Advice to the local planning authority

To LPA	Reading
LPA planning ref no	PL/25/0310
Our ref	pgo-6868
Site address	Former Toys R Us, Kenavon Drive, Reading, RG1 3DH
Proposal description	Conversion of the double height ground floor level space at the southern end of the mid-block to provide 4 residential units (Class C3) at newly created first floor level, various associated alterations and retention of the ground floor Class A3/A4 unit under permission 170509.
Date on fire statement	24/02/2025
Date consultation received	27/03/2025
Date response sent	17/04/2025

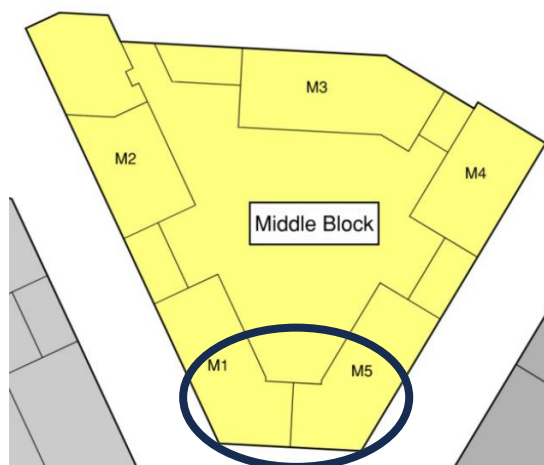
1.8. The proposals seek to introduce a new mezzanine floor to accommodate four 2-bed residential apartments in the middle block Core M1 / M5 (as indicated below). These residential units are proposed at first floor level, filling the void area of unit 4 in Core M1 / M5 at ground floor level, which is currently vacant. No changes to the use at ground floor level are proposed as part of this application. At first floor level, the layout of the proposed residential apartments replicates that of the floor above at second floor level. This ensures that the structural columns are aligned. The fire escape strategy is also the same of that at second floor level.

- 1.9. The commercial unit on the ground floor will not connect to the residential parts of the building and no other changes are proposed to other parts of the building.
- 1.10. HSE welcomes these design modifications, and it will be for the applicant to demonstrate compliance at later regulatory stages.
- 1.11. Following a review of the information provided with this consultation, HSE is content with the fire safety design, to the extent that it affects land use planning. However, HSE has identified some matters that the applicant should try to address, in advance of later regulatory stages.
